Private Fuel Storage, LLC

**RESPONSE TO EIS REQUEST FOR ADDITIONAL INFORMATION  
PRIVATE FUEL STORAGE FACILITY  
DOCKET NO. 72-22 / TAC NO. L22462  
PRIVATE FUEL STORAGE L.L.C.**

Reference: 1) NRC Letter, Young to Parkyn, Request for Additional Information,  
dated December 18, 1998

- A. Watershed Map (Page 5 of 6)
- B. Floodway Boundary (Page 6 of 6)

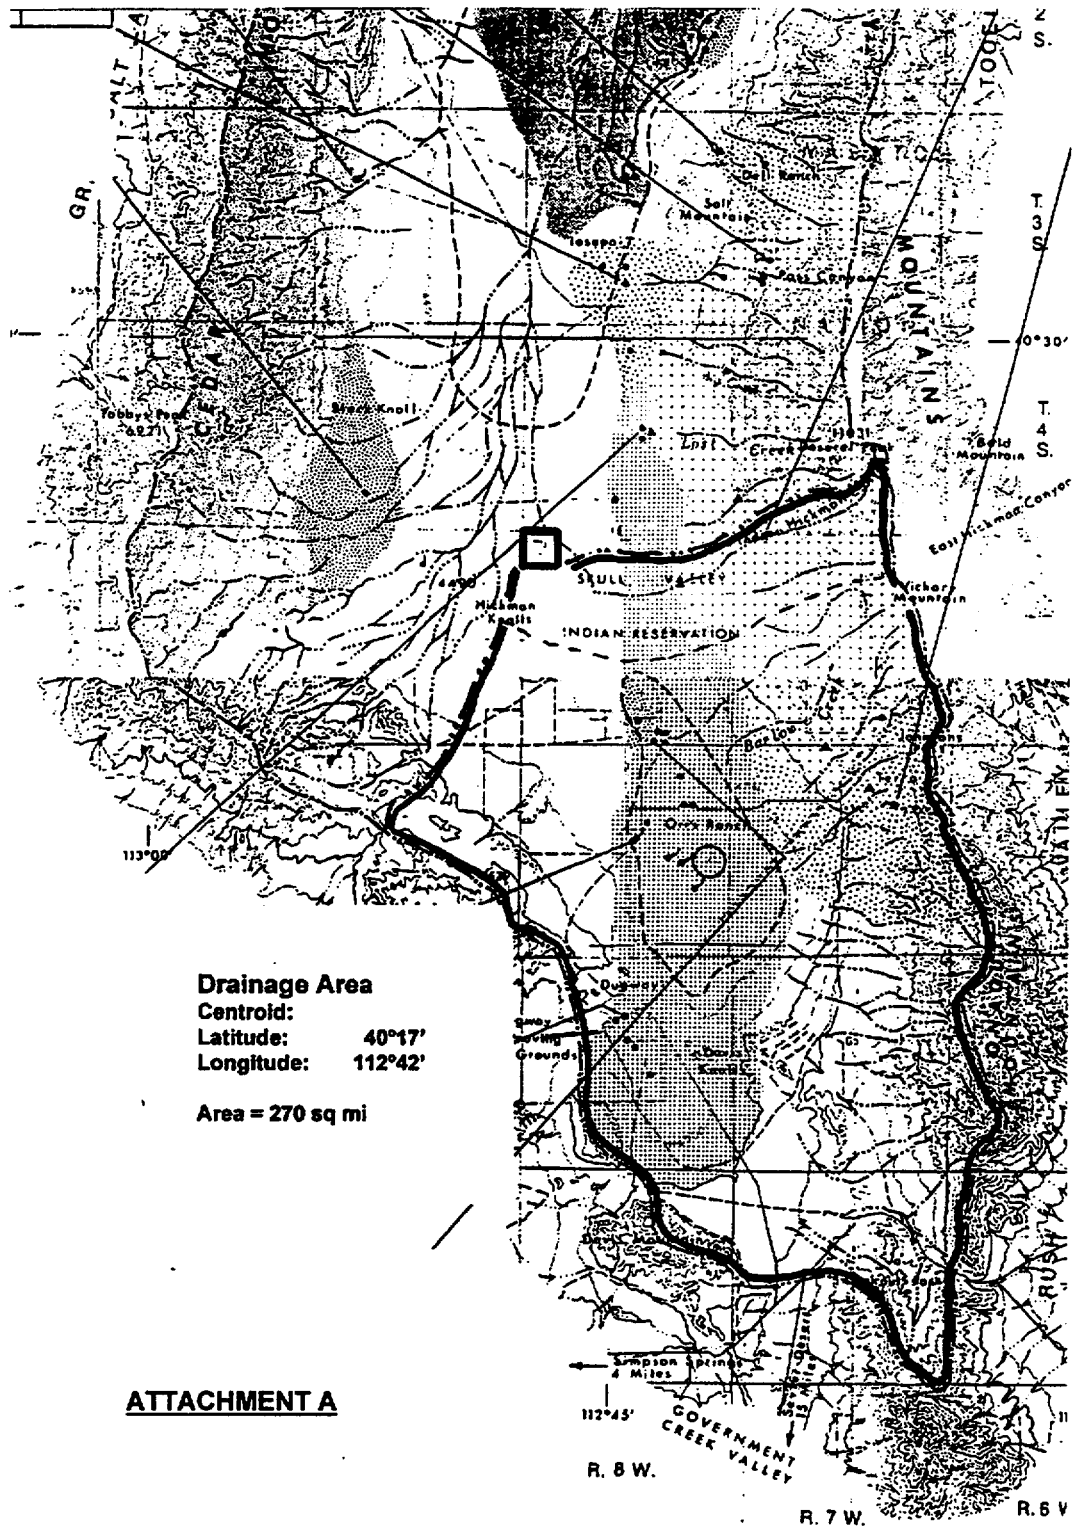
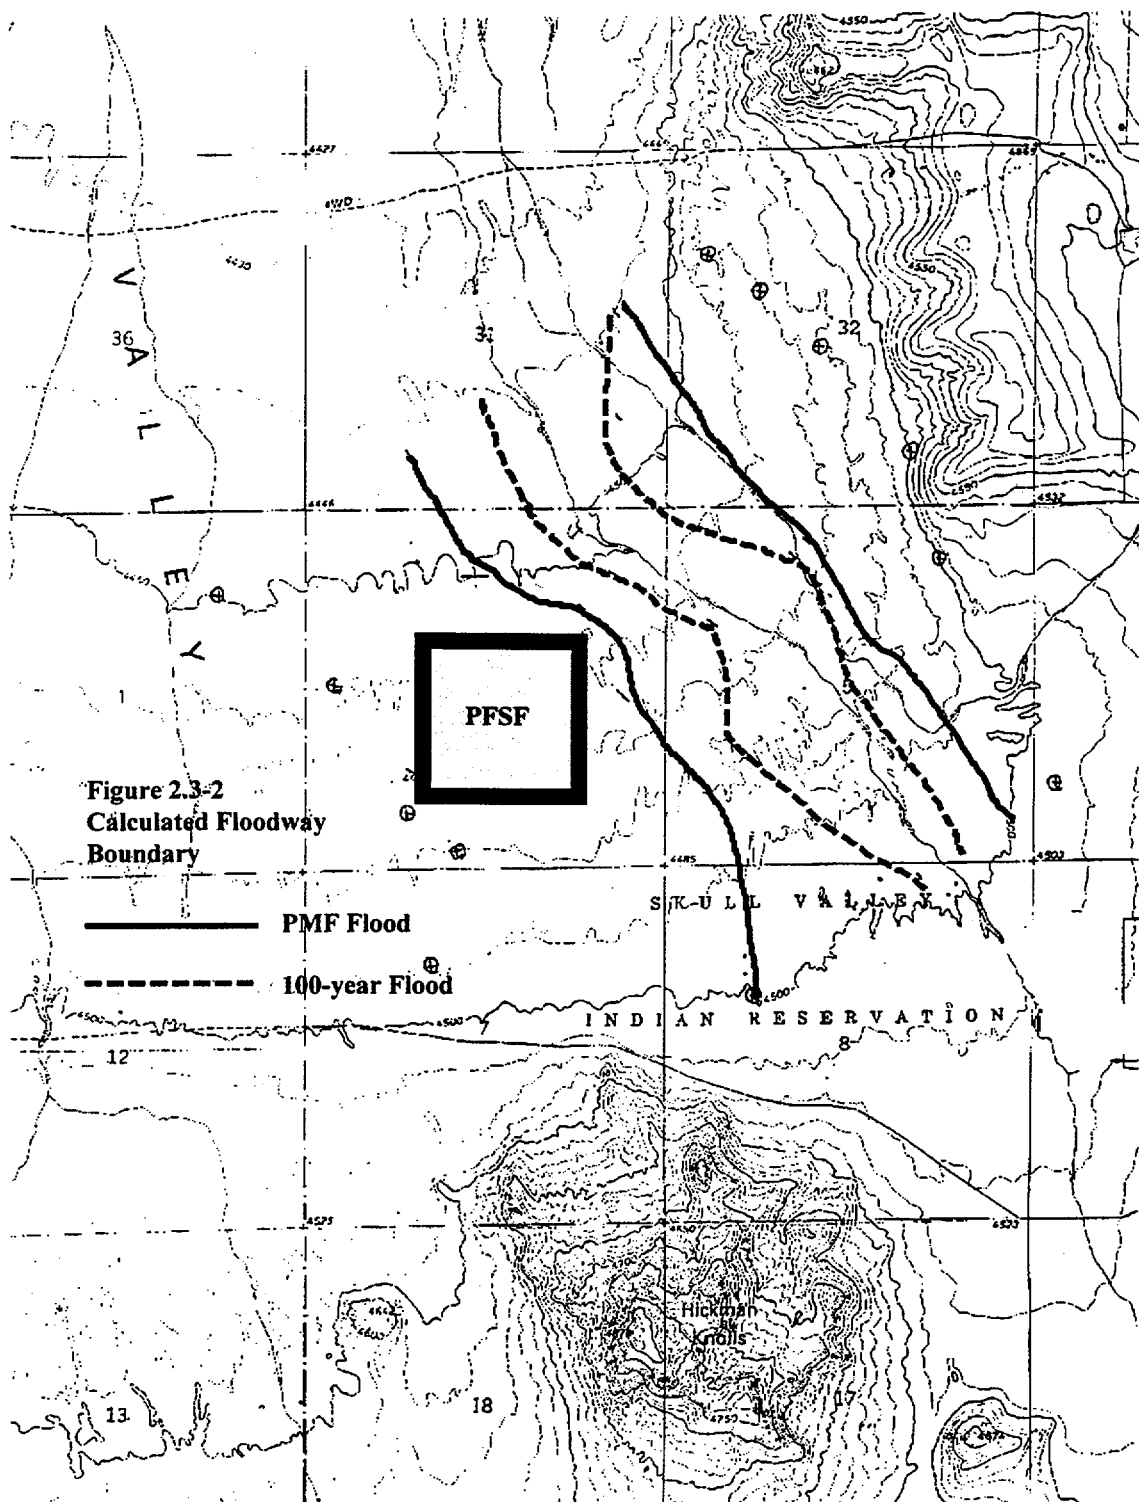
- 8-3    a. Explain why the probable maximum flood (PMF) calculation in the license application identifies a drainage area of 26 miles, rather than a larger area (e.g., 240 square miles) and discuss the potential effects of runoff.
- b. Indicate where the proposed natural drainage system is located.
- c. Provide the basis for the statement on page 4.5-1 that localized aquifer drawdown from facility water use "is not expected to have any effects on adjacent water users."

- a. The PFSF flooding analysis is described in SAR Section 2.4. The watershed basins or drainage areas used in the analysis are shown in SAR Figure 2.4-1. Watershed basin I is approximately 26 square miles in area and comprised of three subbasins that form a discrete drainage system which concentrates and flows to the north on the east side of the PFSF site. The southern boundary of watershed basin I was established based on a field walkdown that identified a subtle saddle or ridge that appeared to segregate the basin as shown on SAR Figure 2.4-1. A flooding calculation (Reference 1) was prepared to determine the 100-year and Probable Maximum Flood (PMF) flow quantities and floodway elevations to confirm the PFSF site is flood-dry. Results of the flooding calculation are summarized in SAR Section 2.4.2.

The calculated flows have increased due to the larger area, but not proportionally. The  $Q_{100}$  has increased from 2,247 cfs (Reference 1) to 2,430 cfs and the  $Q_{pmf}$  has increased from 34,577 cfs (Reference 1) to 53,000 cfs. These new and higher values can and will be accommodated in the design of the access road. It should be noted the design of the access road includes providing culverts to pass the  $Q_{100}$  beneath the road, whereas the  $Q_{pmf}$  would overtop the road surface.

- b. Attachment A shows the natural drainage area.
- c. See response to EIS RAI, Question 8-1 a.

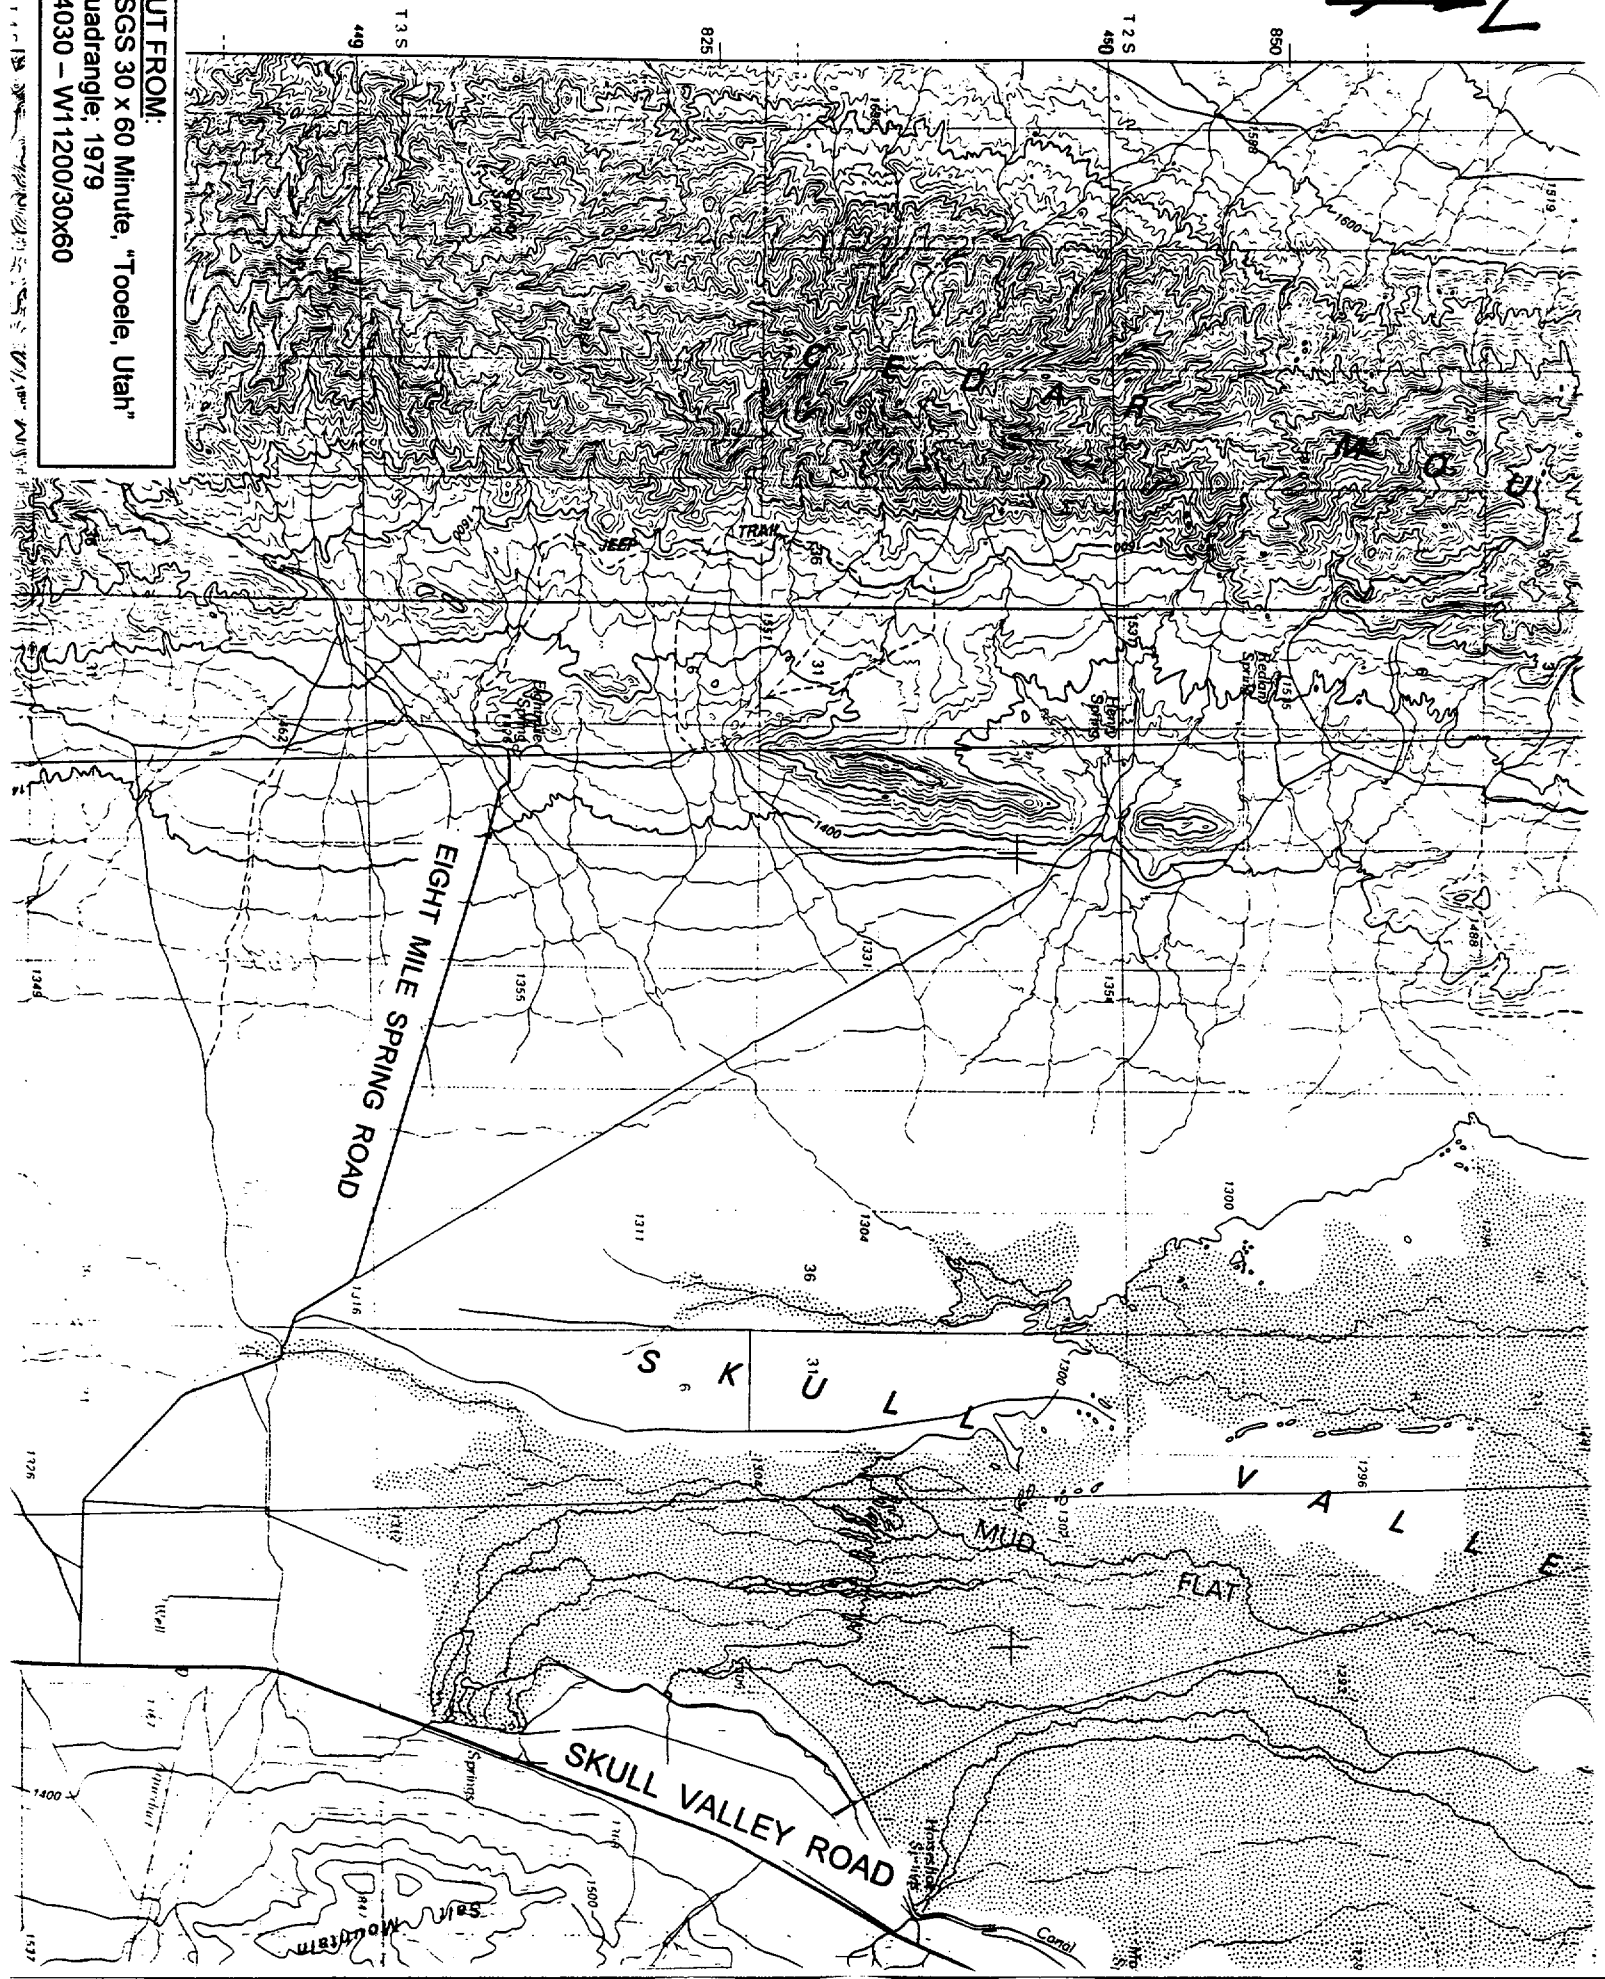
- 11-6. Provide a map depicting the location of Eight Mile Spring Road, mentioned on ER page 4.4-8. Because this road is said to be used by many people, its location is important in assessing the potential traffic impacts of the proposed project.

Eight Mile Springs Road is shown on the attached map photocopied from USGS 30 x 60 minute Quadrangle, "Tooele, Utah". It is also shown on USGS 7.5 minute Quadrangles titled, "Salt Mountain, Hastings Pass, and Quincy Spring". The intersection of Eight Mile Spring Road and Skull Valley Road is located on Quadrangle "Salt Mountain" at T3S/R8W, Section 21.
